**Addendum I to the DeKalb
County Department of Watershed
Management *Potable Water Main,
Gravity Sanitary Sewer, and Sanitary
Sewer Pump Station and Force Main
Design Standards Manual***

The purpose of this addendum is to provide updated design criteria, construction requirements, standard details, and other pertinent information to the latest *Potable Water Main, Gravity Sanitary Sewer, and Sanitary Sewer Pump Station and Force Main Design Standards, Edition 2017, Version 0* (Design Standards Manual).

This addendum to the DCDWM Design Standards Manual, Edition 2017, Version 0 will become effective February 22, 2019.

G-008 Thrust Restraint (150 psi) Tie-rod Installation Detail (02/2019)

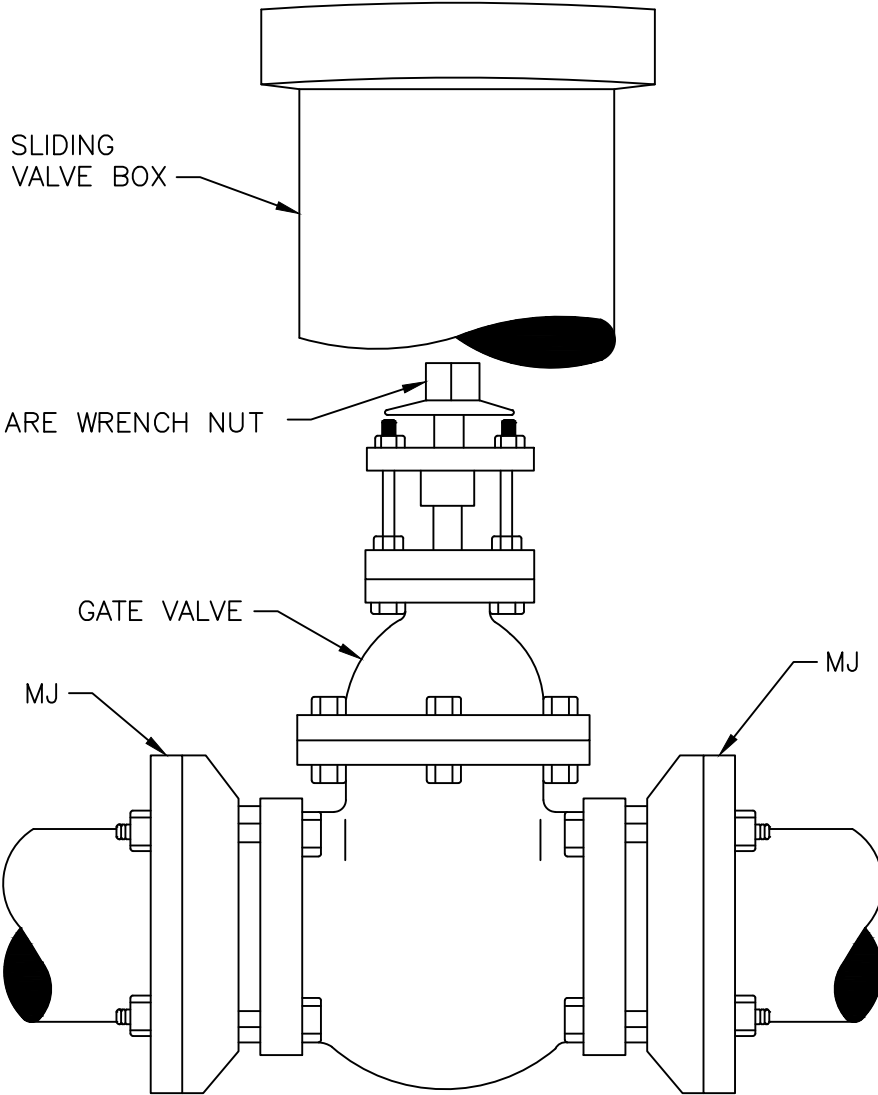
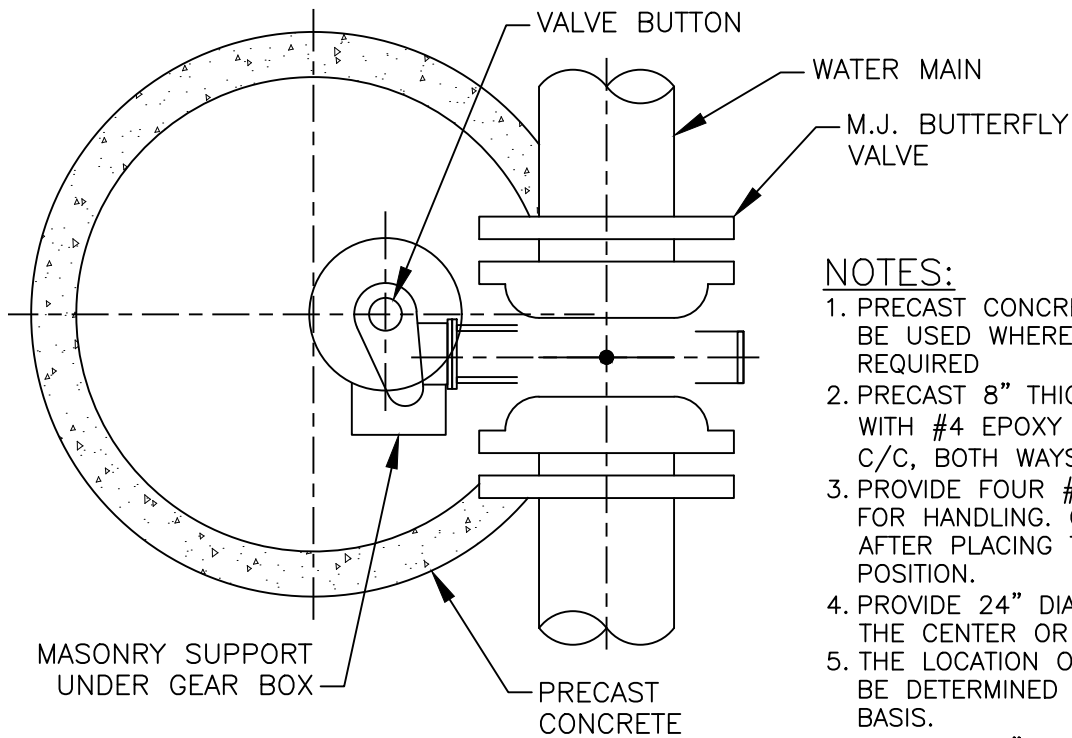
d) Detail G-008, Thrust Restraint (150 psi) Tie-rod Installation Detail (09/2017), DELETE:

REPLACE WITH:

STANDARD DETAILS	02/19
	Butterfly Valve And Vault Assembly No. 2 (Requires DCDWM Approval) NOT TO SCALE	
		DETAIL NO. W-027

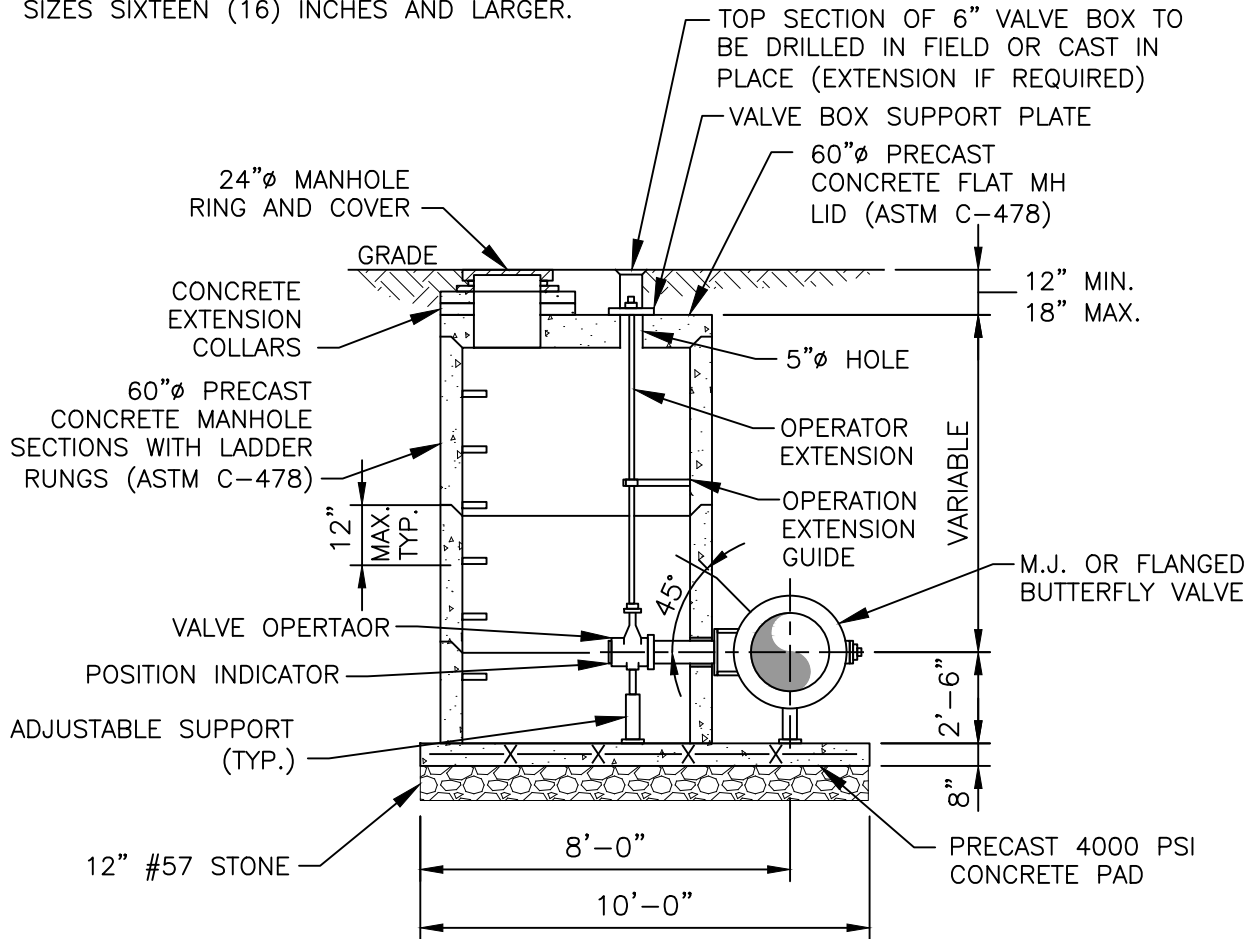
Detail W-027, Butterfly Valve and Vault Assembly No. 2 (02/2019)

1. BUTTERFLY VALVES SHALL ONLY BE USED IN SIZES SIXTEEN (16) INCHES AND LARGER.

DETAIL NO. S-001

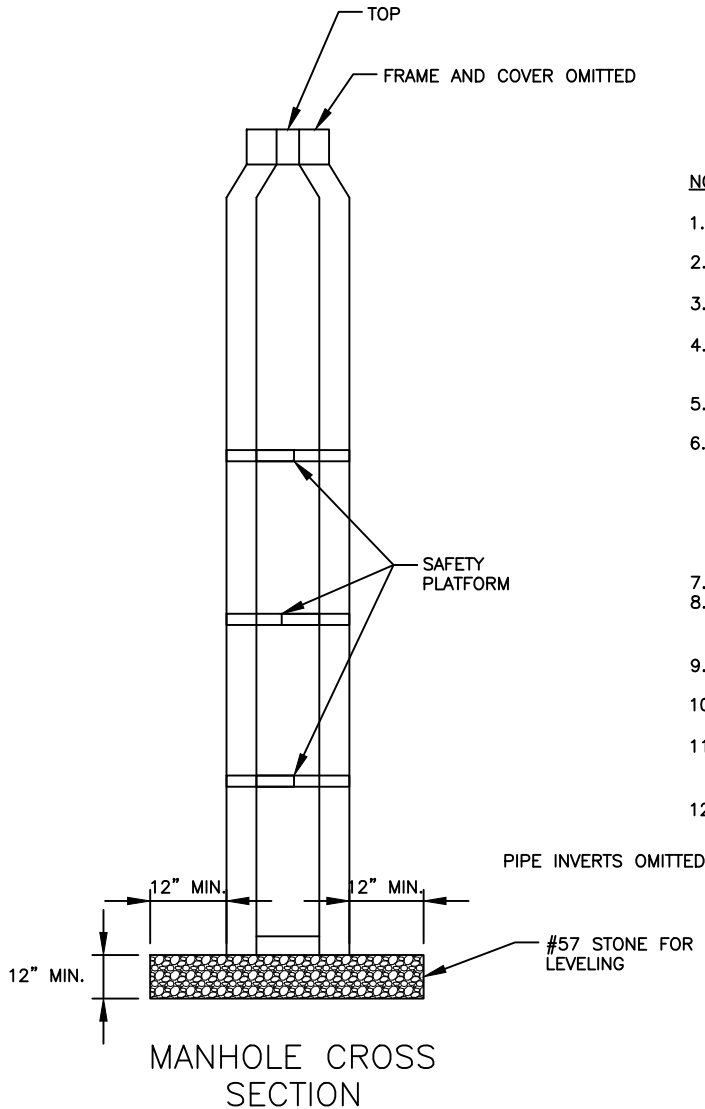
Detail S-001, Standard Precast Manhole (02/2019)

1. WHERE NECESSARY TO CONSTRUCT MANHOLE OVER EXISTING SEWER, 9" THICK CONCRETE POURED-IN-PLACE FOOTING/FOUNDATION MAY BE USED IN LIEU OF PRECAST BOTTOM SECTION.
2. WHERE DROP FROM INVERT OF MANHOLE TO INVERT OF INFLUENT PIPE(S) EXCEED 2'-0", AN INSIDE DROP CONNECTION SHALL BE REQUIRED EXCEPT WHEN DCDWM SPECIFICALLY APPROVES ITS ELIMINATION. SEE DETAILS S-003 OR S-027.
3. PRECAST ALL OPENINGS FOR PIPE IN BASE AND RISER UNITS.

STANDARD DETAILS	02/19
	Outside Drop Connection For Precast Manhole (Requires DCDWM Approval) NOT TO SCALE	
		DETAIL NO. S-003

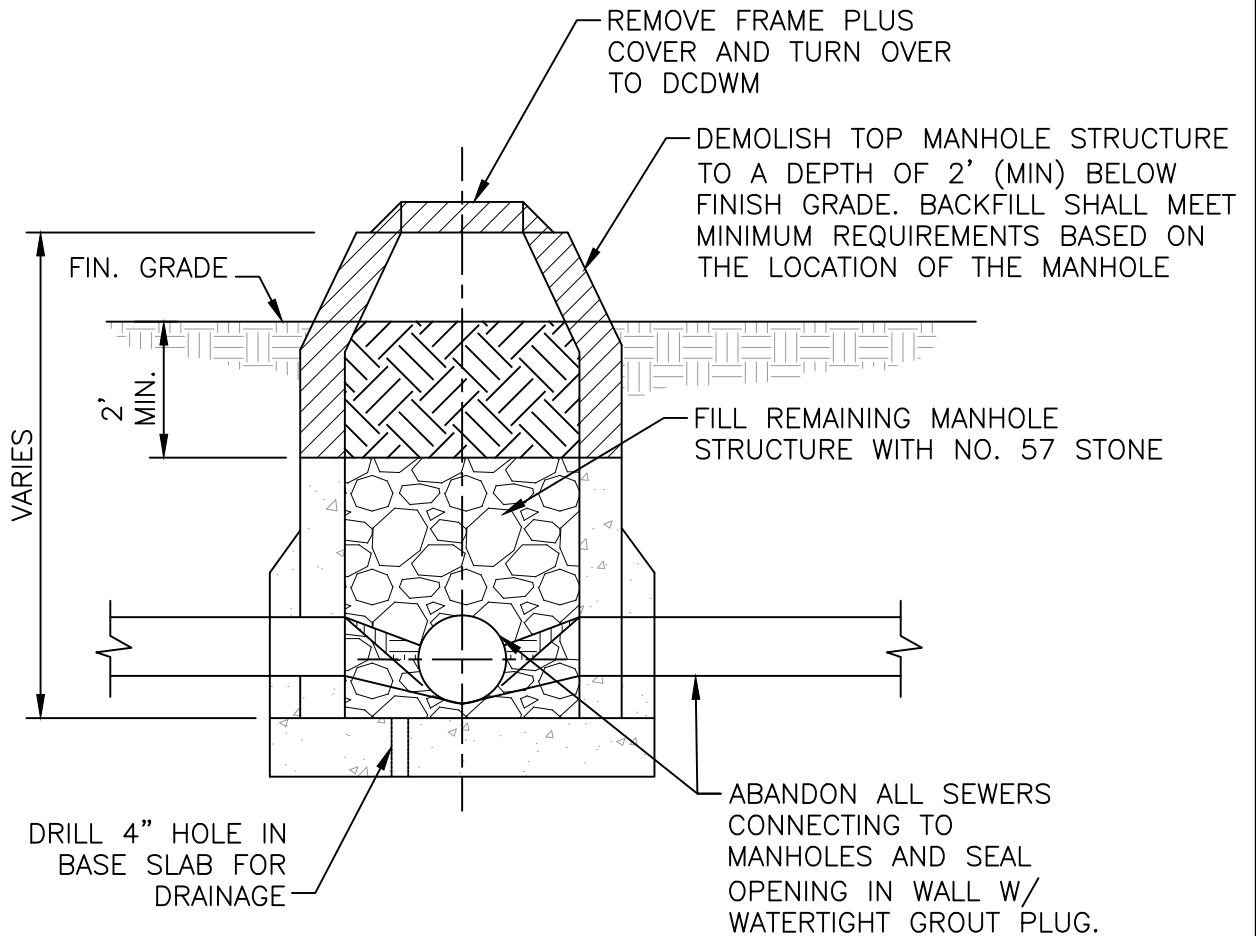
Detail S-003, Outside Drop Connection for Precast Manhole (02/2019)

- NOTES:
1. "DROP CONNECTION" SHALL INCLUDE THE EXCAVATION, MH CORE, CONCRETE, DIP, FITTINGS AND OTHER INCIDENTALS NECESSARY TO COMPLETE THE ITEM. DUCTILE IRON PIPE (18' MIN) INSTALLED UPSTREAM OF THE TEE.
 2. ALL BENDS, TEES, AND FITTINGS REQUIRED TO INSTALL OUTSIDE DROP SHALL BE DUCTILE IRON.

DETAIL NO. S-008

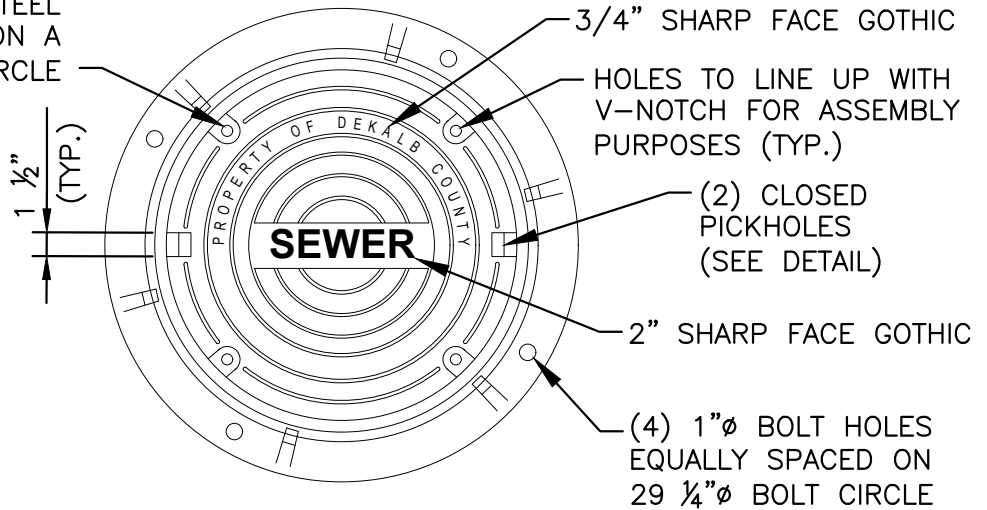
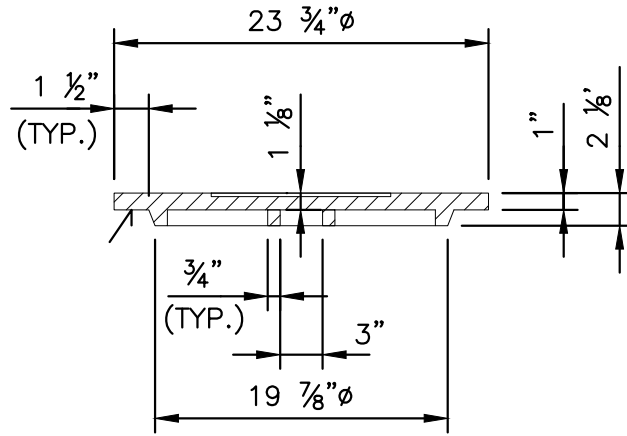
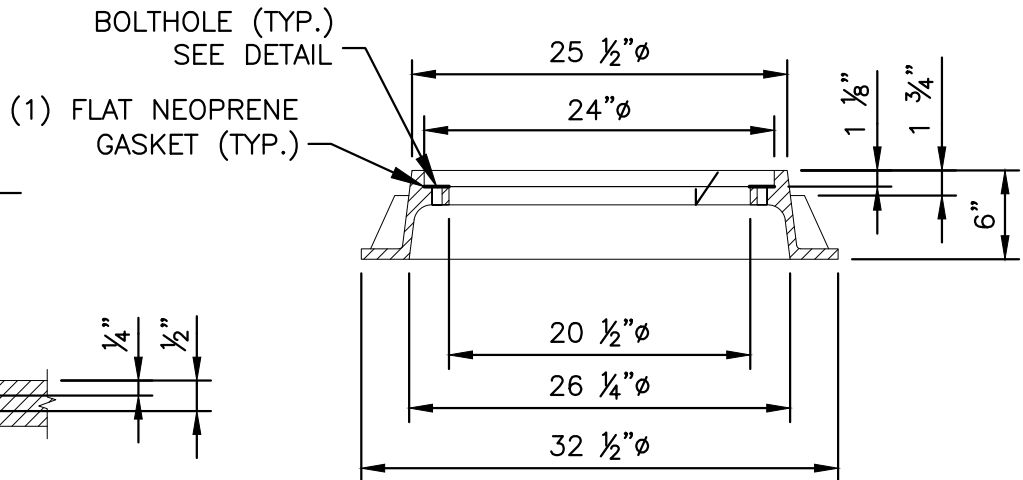
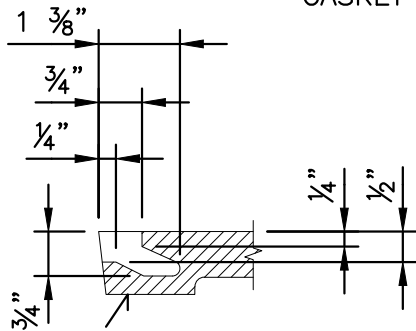
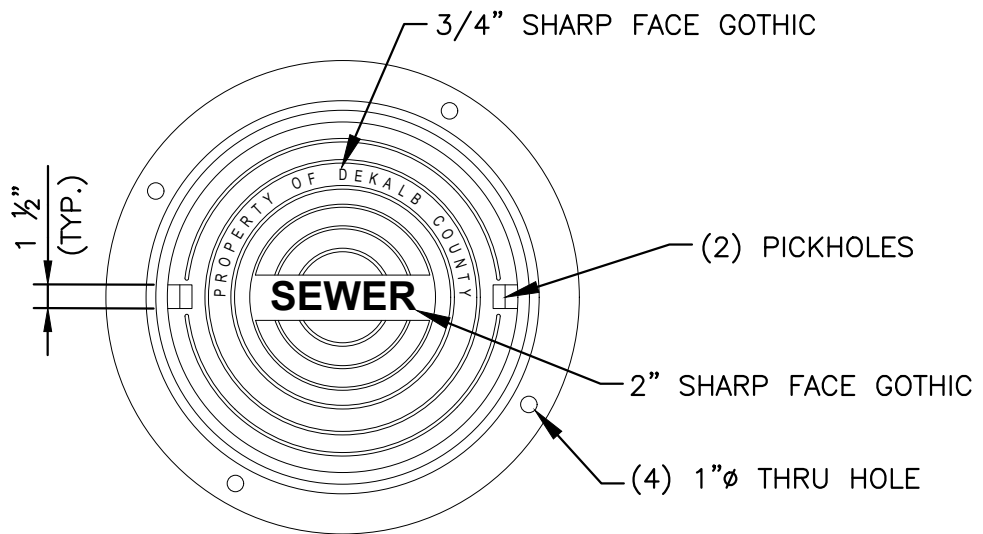
Top of cover shall be factory imprinted to read "**Property of DeKalb County Sewer**" as shown in Detail S-008.

Detail S-008, Bolt Down Manhole Frame and Cover (02/2019)

- MATERIALS:
 FRAME: GRAY IRON (CL35B)
 COVER: GRAY IRON (CL35B)
- DESIGN LOAD
 HEAVY DUTY
- COATING: UNDIPPED
- ✓ DESIGNATES MACHINED SURFACE

DETAIL NO. S-009

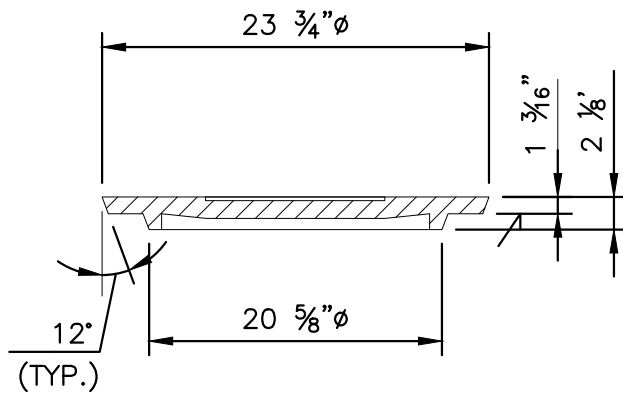
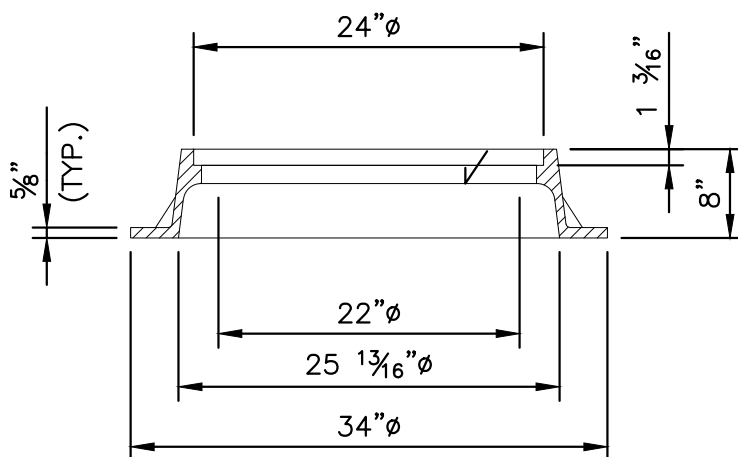
Manhole frames and covers within paved areas shall meet the latest revision of ASTM A48, Class 35B. Covers are to be solid with exception of pick hole(s) located at the cover's circumference, not protruding through the cover. Cast iron frames and covers shall be matched for proper fit. The cast iron frame for the manhole cover shall be set at the required elevation and properly anchored to the precast manhole. Refer to Standard Details S-008 and S-009 in **Appendix B** for manhole frame and cover requirements in paved areas. With **DWM's** approval, the **Contractor** may use an ERGO type ring and cover. Approved manufacturers are ERGO by EJ - americas.ejco.com/hinged-manhole-cover, or approved equal. Composite MH frames and covers (bolt down and capable of H20 loading), **ATG –**

Detail S-009 Traffic Manhole Frame and Cover (02/2019)

- MATERIALS:
 FRAME: GRAY IRON (CL35B)
 COVER: GRAY IRON (CL35B)
- DESIGN LOAD
 HEAVY DUTY
- COATING: UNDIPPED
- ✓ DESIGNATES MACHINED SURFACE
